Re: Indian Point Unit No. 2
Docket No. 50-247

SUBJECT: Response to the NRC Generic Letter 96-04:
Boraflex Degradation in Spent Fuel Pool Storage Racks

**CONSOLIDATED EDISON COMPANY OF NEW YORK, INC.
INDIAN POINT UNIT NO. 2
DOCKET NO. 50-247
October, 1996**

Figure 1: Indian Point Unit 2 Spent Fuel Pool Reactive Silica Level

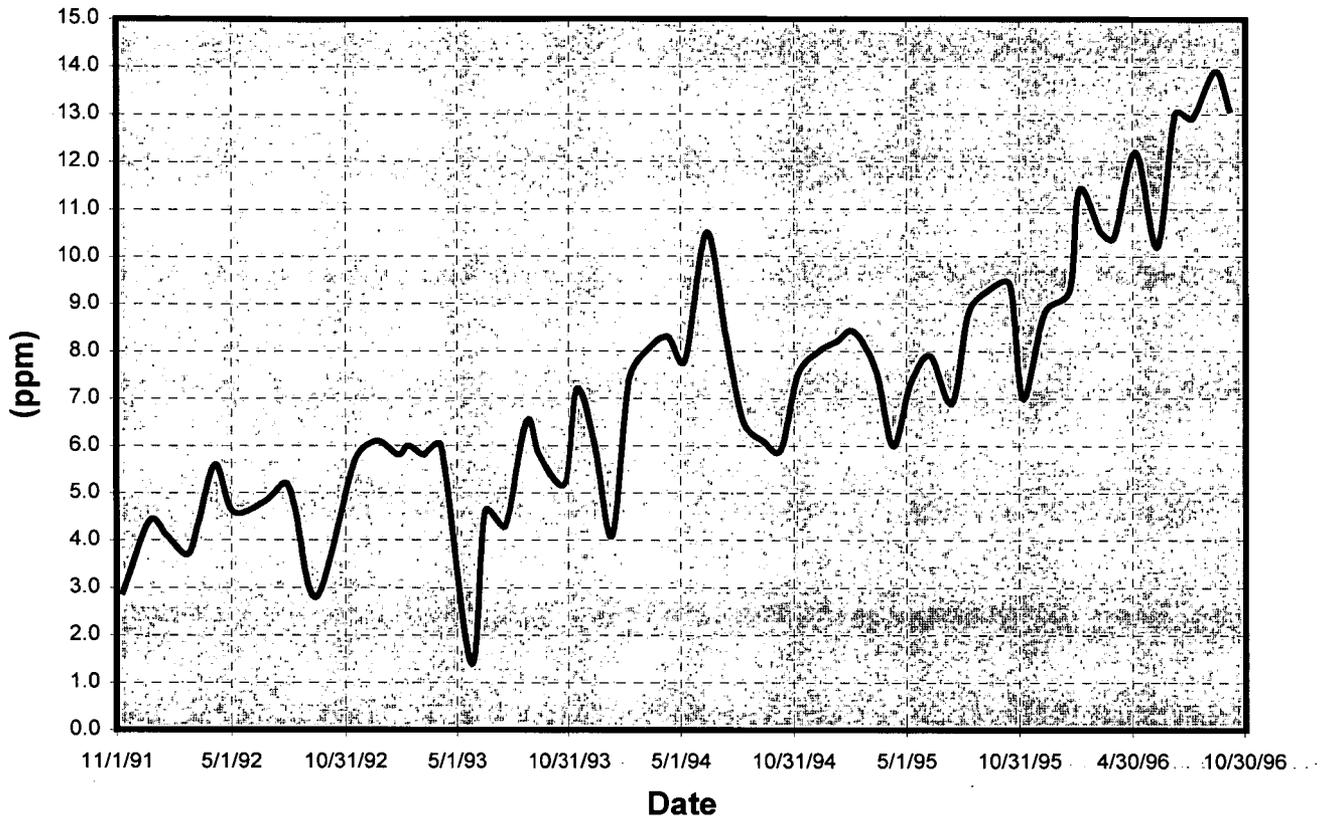
3. Describe the results from any previous post operational blackness tests and state whether blackness testing, or other in-situ tests or measurements, will be periodically performed. Chronological trends of pool reactive silica levels, along with the timing of significant events such as refuelings, pool silica cleanups, etc., should be provided. Implications of how these pool silica levels relate to Boraflex performance should be described.

Chronological reactive silica level data at Indian Point Unit 2 spent fuel pool since November 1991 are listed in Table 1. The graph showing the trend of the reactive silica level is shown in Figure 1. The timing of significant events such as refuelings, resin changes, etc. is also shown in Figure 1. At Indian Point Unit 2, reverse osmosis cleanup has never been performed.

The reactive silica level is monitored for both magnitude and trends. As of October 1996, the reactive silica level at Indian Point Unit 2 spent fuel pool is 13.1 ppm. As for the rate of increase in the reactive silica level, it is about 2.5 ppm per year since November 1991.

This silica level is not indicative of accelerated Boraflex dissolution.
